MITCHELL CHILDCARE CENTRE
BLOCK 18, SECTION 11 CORNER DARLING &
HEFFERNAN STREET, MITCHELL, ACT

has been commissioned to provide access consulting services for the proposed Mitchell Childcare Centre at Block 18, Section 11, corner Darling & Heffernan Streets, Mitchell ACT.

The report is provided for submission at the Town Planning Stage. This development is subject to further design reviews to achieve compliance with NCC/BCA and AS1428.1:2009. Issues listed below can be achieved with further Design Development.

SITE PLAN					
Drawn	Date	Scale	Project Number		
Review	Date	Project Leader	Date		
PRELIMINARY			Drawing Number	Amtd	
			SK101	B

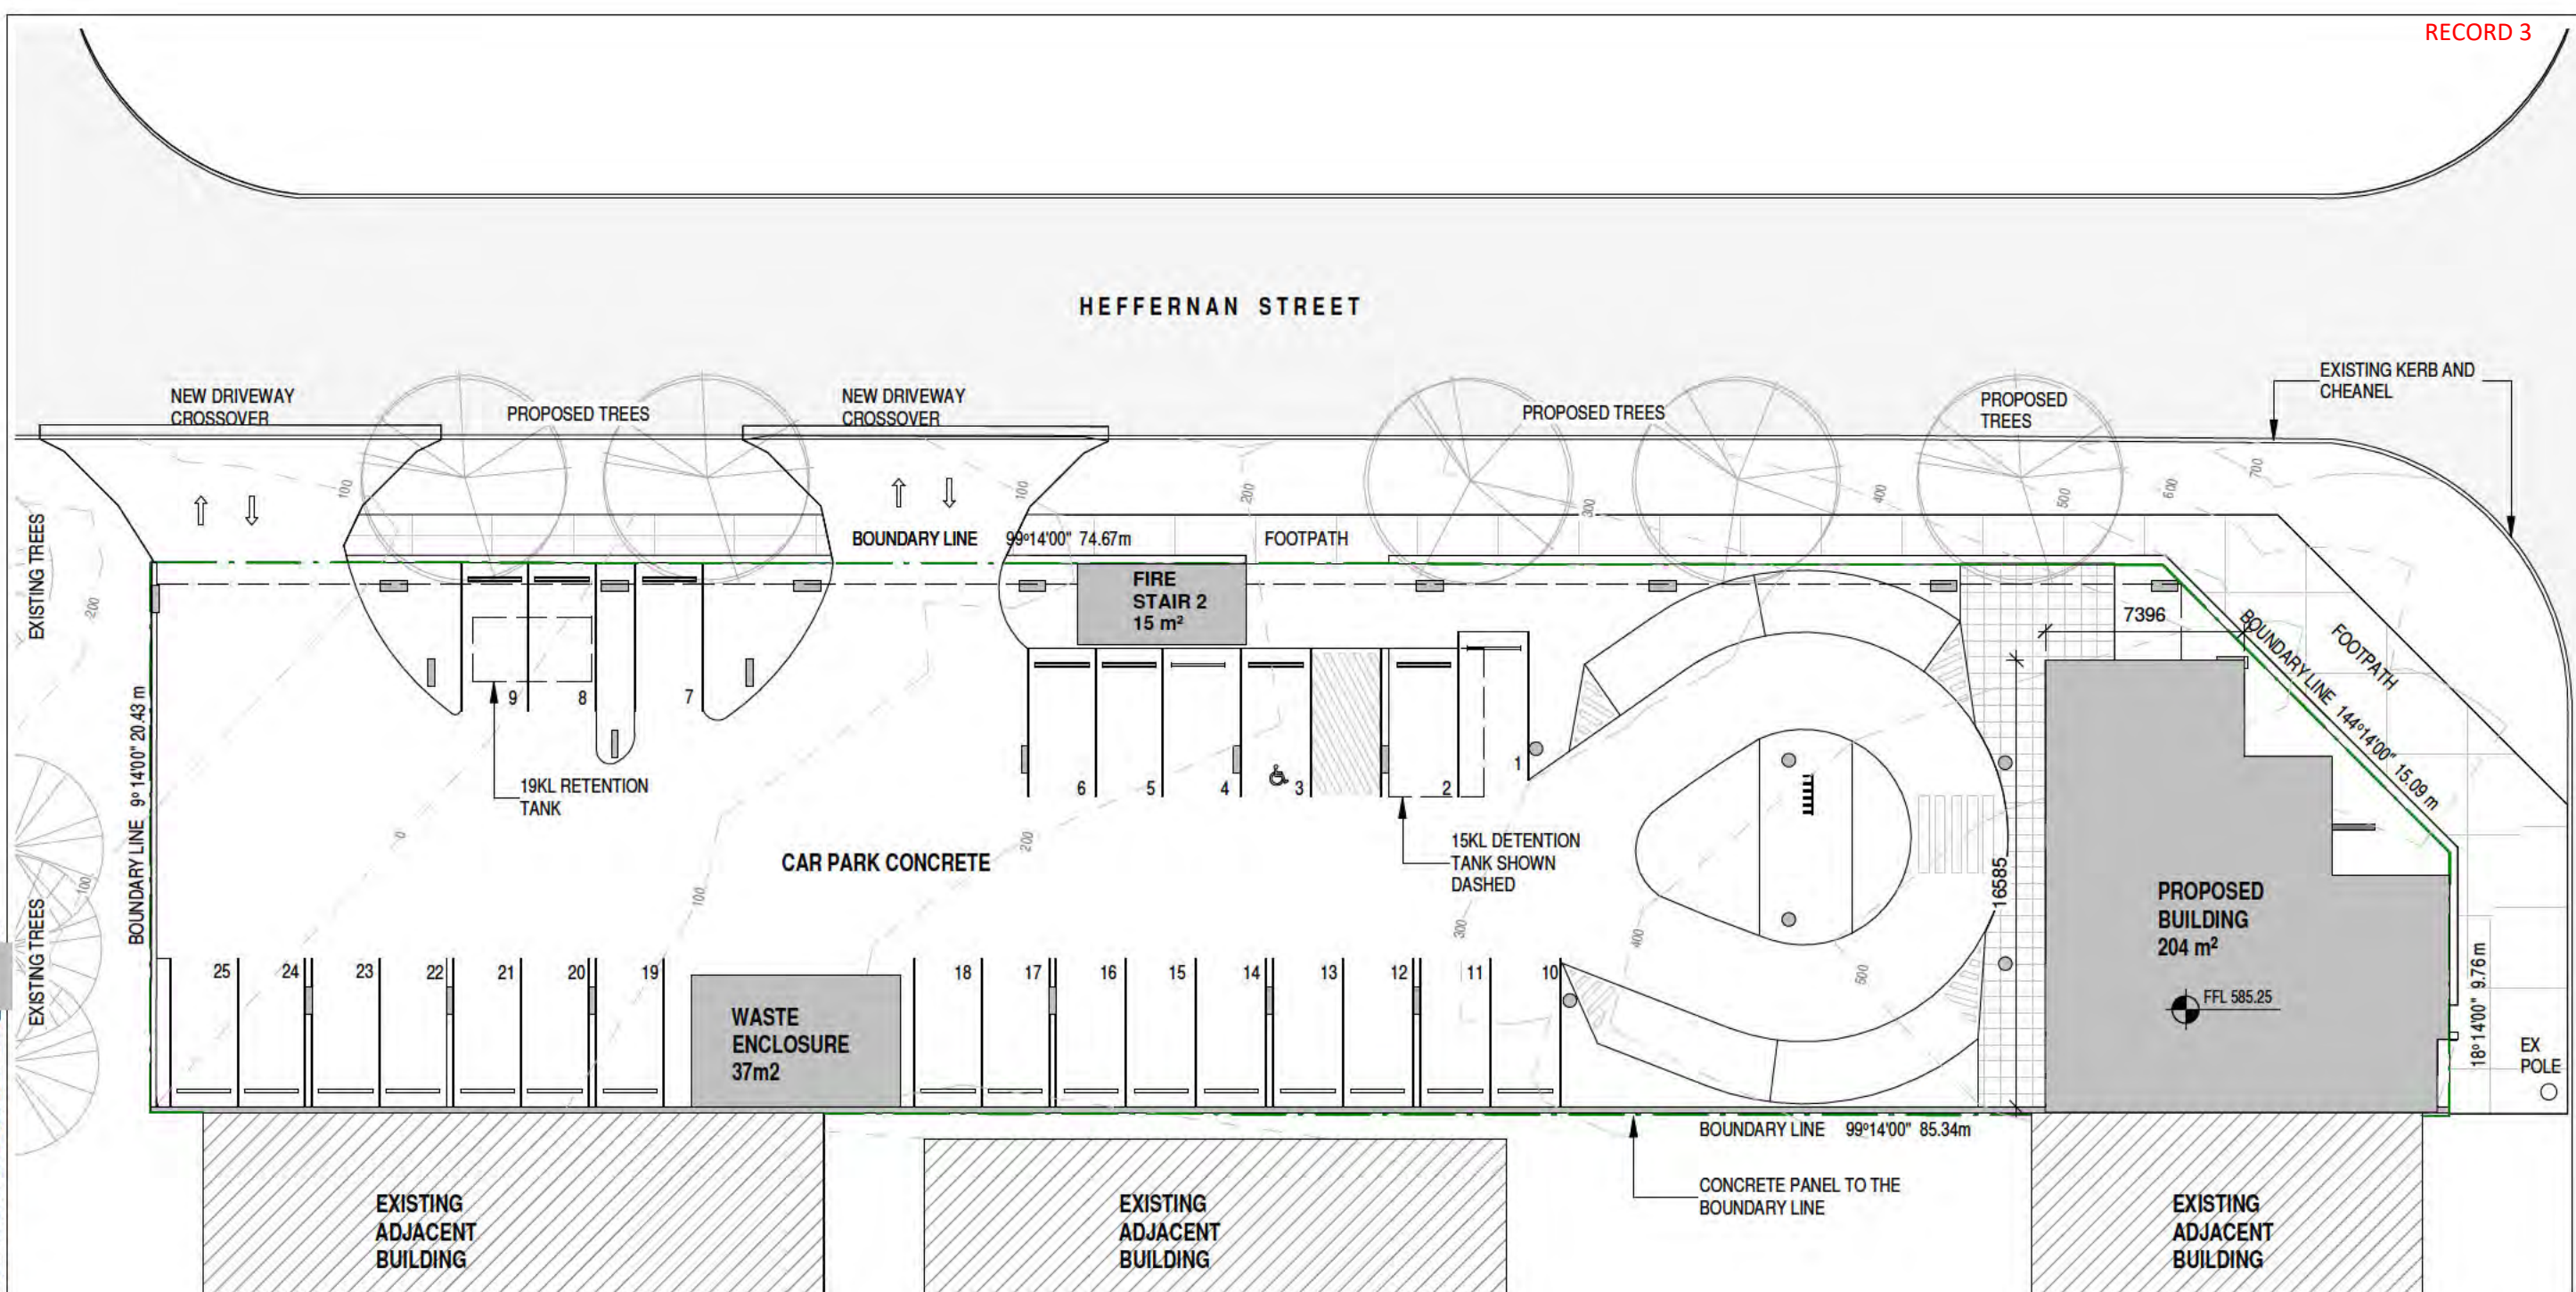
- One accessible car space satisfies the minimum requirement of NCC/BCA of 1 space for every 50 car parking spaces provided on site.
- Accessible car park: The surface of car park and adjacent shared area is not indicated at this stage. Provide car park area with a firm, even and slip-resistant surface, and at the same level as the parking space. [REDACTED] have been advised that the path of travel would be out to the street footpath and then back in via the paved area at the top of the turning circle driveway.
- Car park/shared space/walkway: Provide gradient and crossfall no steeper than 1:40.
- Depending on location of walkway, provide a kerbramp to transition from shared space to walkway.

Provide a slip resistance and smooth firm even surface, with gradients no steeper than 1:20 with a crossfall no steeper than 1:40.

Drawn	Date	Scale	Project Number
		1 : 250	A3
Review	Date	Project Leader	Date
PRELIMINARY			Project Number A17041
			Drawing Number SK102
			Amnt. B

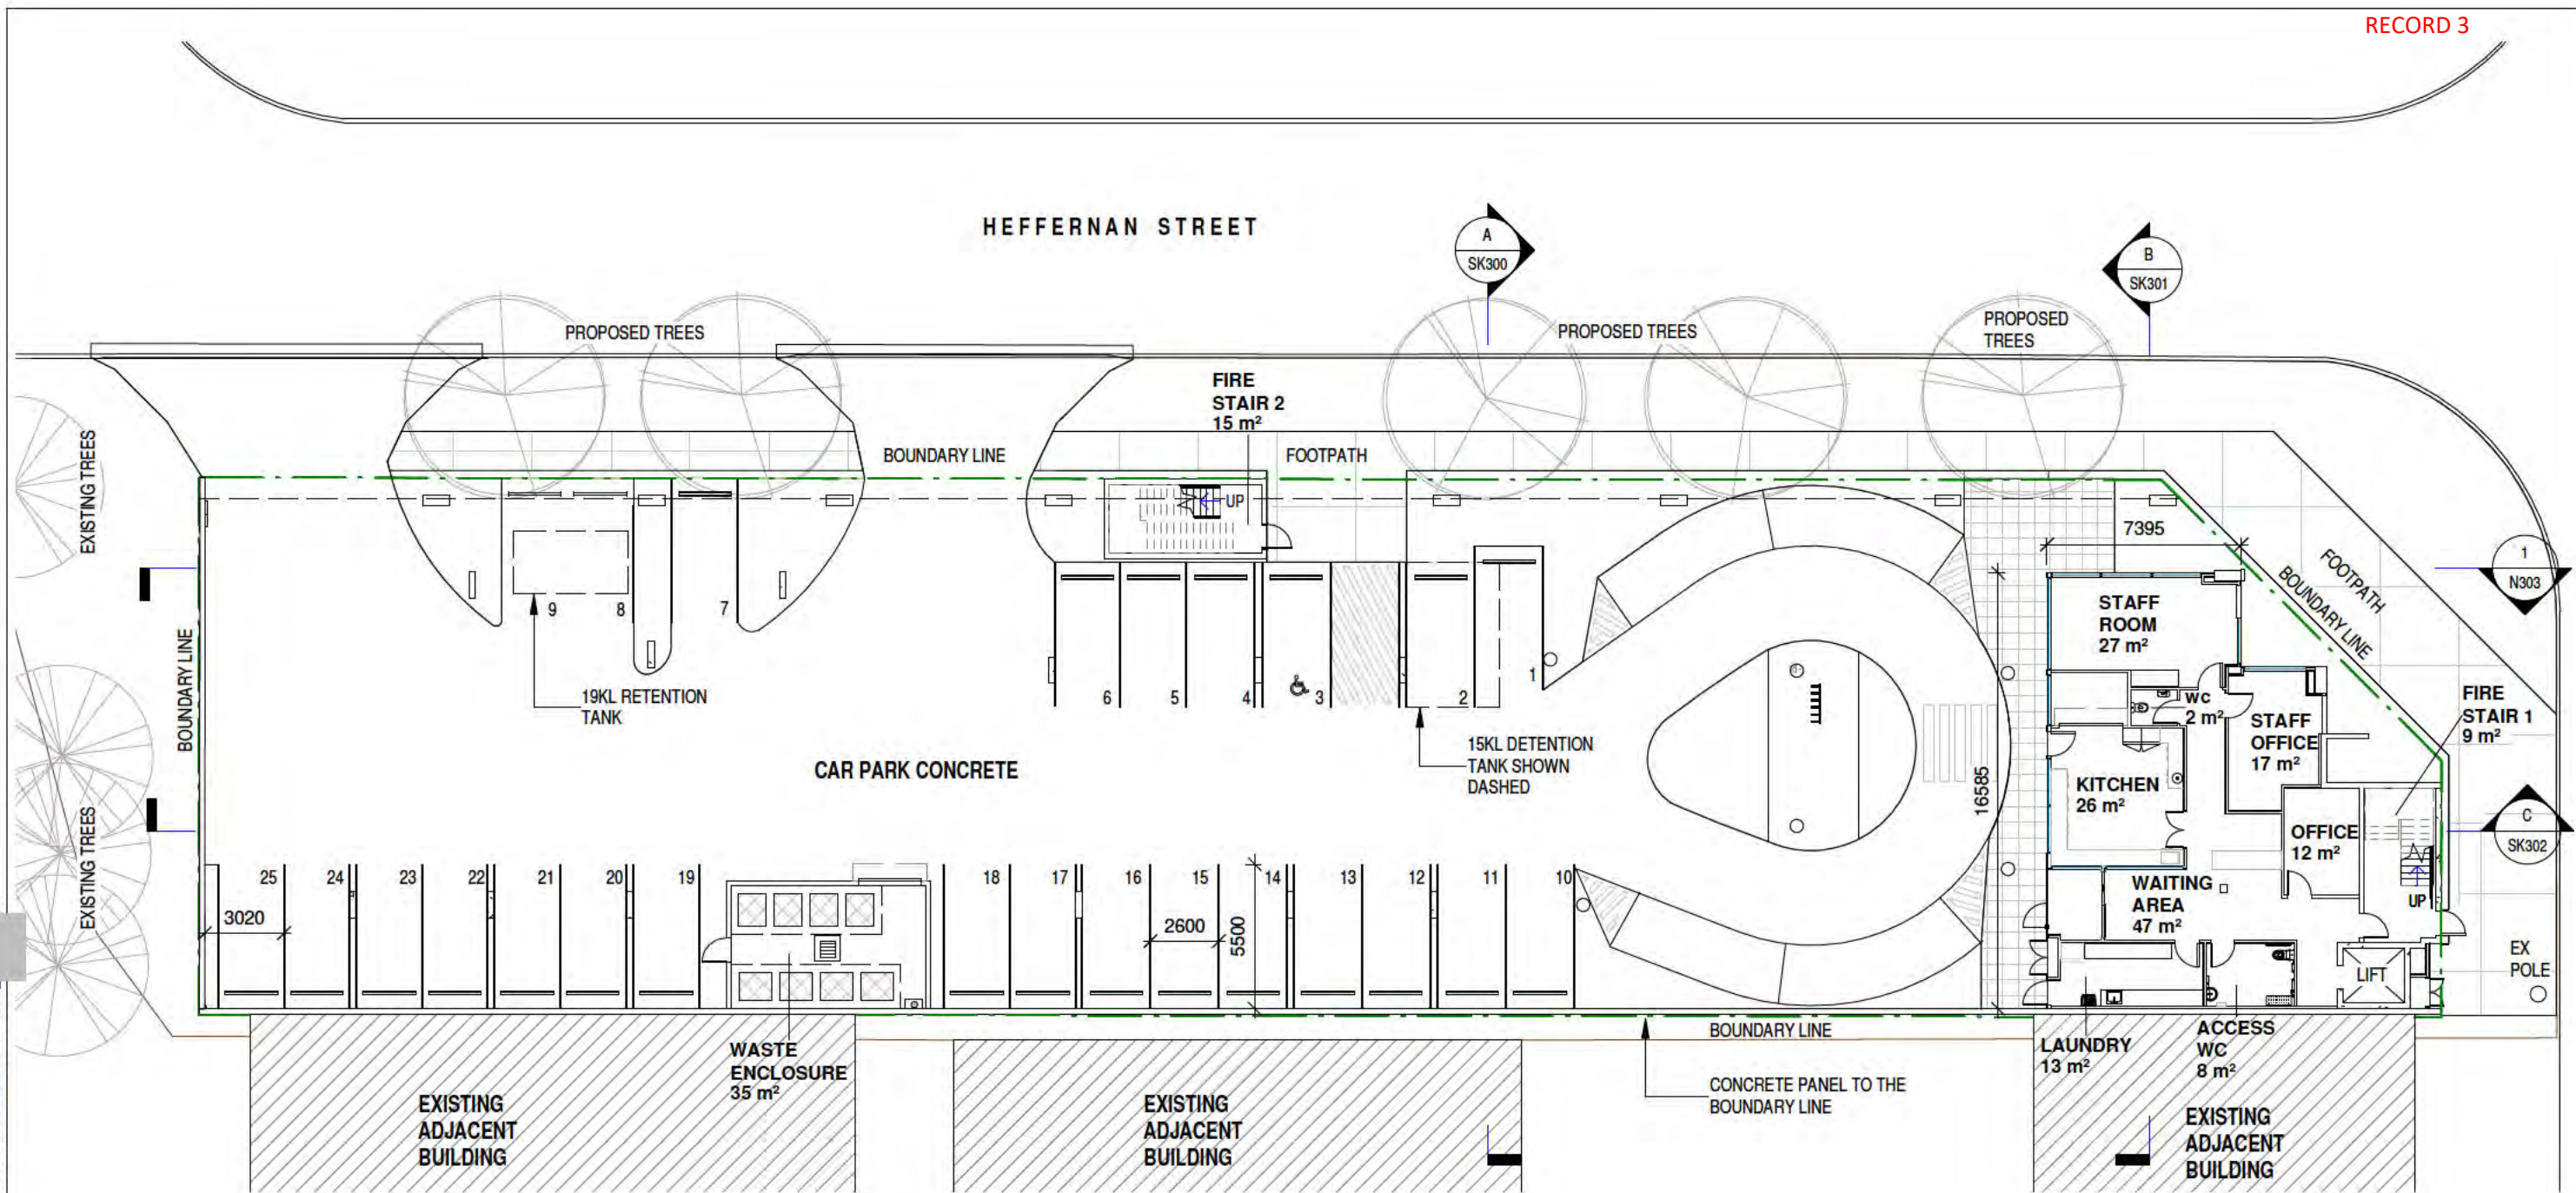
- Ground Floor door to Staff Room lacks internal and external latchside clearances. Provide 510mm for external and 530 mm for internal, as a minimum for latchside clearances.

- Ground Floor doors to Laundry lacks internal latchside clearances. Provide a minimum 530 mm latchside clearance.
- Ground Floor external door to Kitchen lacks internal latchside clearances encroached by fixture. Provide a minimum 530 mm latchside clearance.

- Ground Floor internal double doors to Kitchen scales with 680mm door leaves, lacks clear opening through active leaf. Provide a minimum 920mm active door leaf to provide a minimum 850mm clear opening.

- Ground floor corridor to Staff Room scales at 985mm width. Provide a minimum 1000mm width between skirting boards, and door circulation for side on or front on approach.
- Ground floor corridor to Staff Room and First floor corridor lacks turning space at the end of the corridor. Provide 2070mm long x 1540mm wide to be provided within 2m of the end of an accessway.
- Laundry lacks internal turning space. Provide 2070mm long x 1540mm wide turning space.
- First Floor Toddlers Prep/Store and Cot rooms lacks internal turning space. Provide 2070mm long x 1540mm wide turning space.

Reception joinery details will need to be reviewed further, as clearance behind counter scales at 1400mm. Recommend to provide 1540mm clearance behind counters for staff access.

The Ground Floor facility with a shower scales at approximately 2380mm width x 3325mm length, and First Floor facility with a shower scale approximately 2400mm width x 3200mm which can achieve compliance for the indicated layouts, providing pan, shower and basin circulation space. Recommend First Floor UAWC to provide soap dispenser and hand dryer on door wall to avoid conflict with shower circulation, and to be located not within 500mm of internal corner.

Ground Floor provides one separate gender sanitary facility adjacent to staff areas, This is required to be provided as a cubicle for persons with ambulant disabilities, as associated with a UAWC on ground level. Provide an Ambulant Cubicle as per AS1428.9:2009 Clause 16.

Drawn	Date	Scale	Project Number
Review	Date	Project Leader	Date
PRELIMINARY		Drawing Number	Amnt
		SK103	B

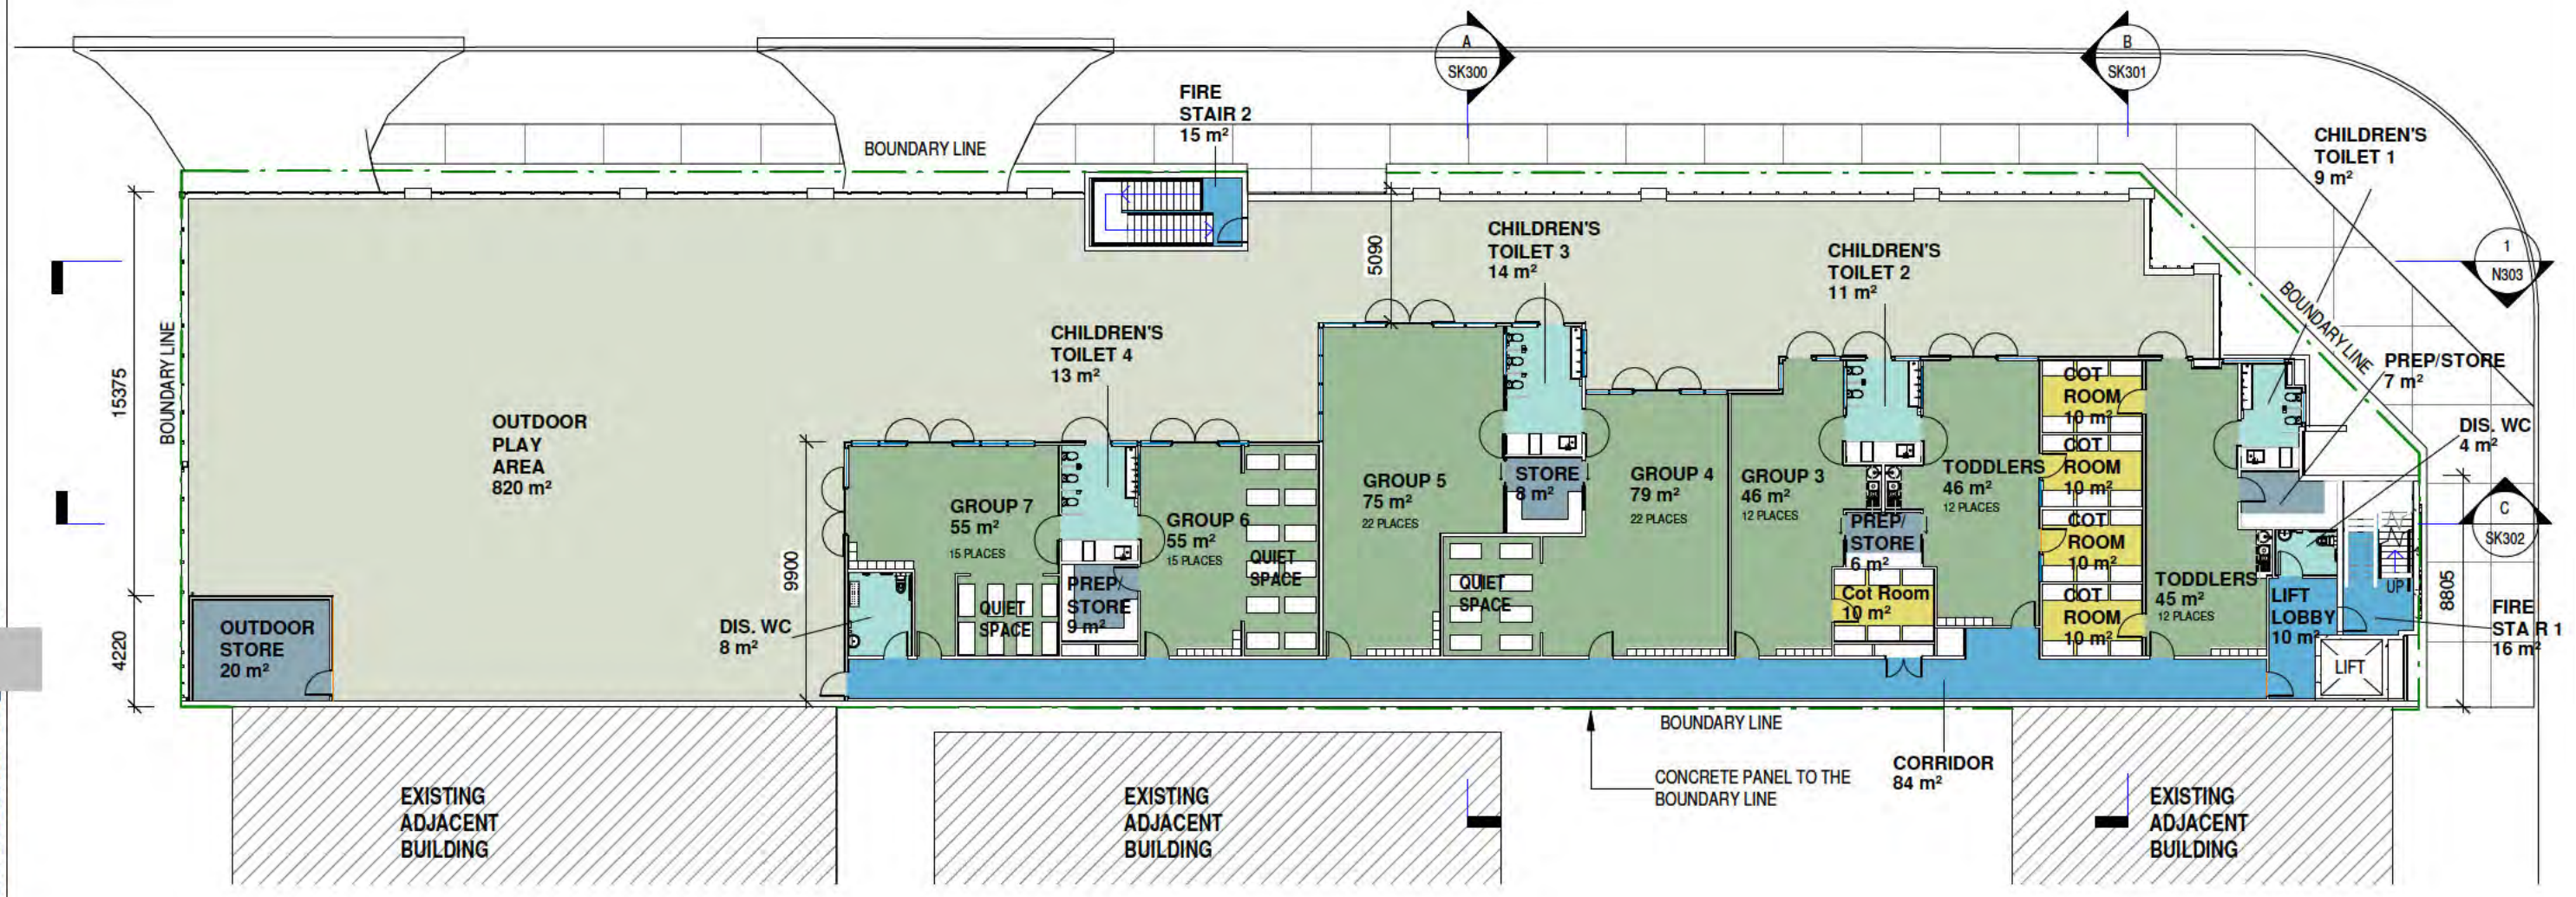
- First Floor doors at either end of corridor lack internal latchside clearance. Provide latchside clearance.
- First Floor entry door to Group 7 room lacks internal latchside clearance. Provide latchside clearance.

- First Floor entry door to Group 6 room and Prep/Store lacks internal latchside clearance due to fixture. Provide latchside clearance.
- First Floor external double doors to Outdoor Play Area scales with 850mm door leaves, lacks clear opening through active leaf. Provide a minimum 920mm active door leaf to provide a minimum 850mm clear opening.

- First Floor entry door from Group 4 room to Childrens Toilet 3 lacks external latchside clearance due to wall. Provide latchside clearance.
- First Floor sliding doors to Prep/Stores lack clear opening as opening scales at 970mm. Provide a minimum 1020mm opening to provide minimum 850mm clear opening, providing d-pull handles with a clearance from the door jamb of 60mm in the open or closed position.

- First Floor entry door to Cot rooms and Toddlers Prep/Store lacks internal latchside clearance due to fixture. Provide a minimum 530 mm latchside clearance.

- First Floor entry door to Children's Toilet 1 & 2 lacks internal latchside clearance due to fixtures. Provide latchside clearance.

The First Floor Unisex Accessible WC adjacent to lift scales at approximately 1780mm width x 2360mm length. Room size is not compliant. Review room size to provide compliant layout and pan circulation. Refer to Building Certifier as room may not be required to be a compliant UAWC as two provided.

Recommended to consider emergency evacuation needs of persons with disability from First Floor. Consider emergency refuge area (1300 x 800mm) within or near the egress stair adjacent the lift. Provide means of communication with any refuge area.
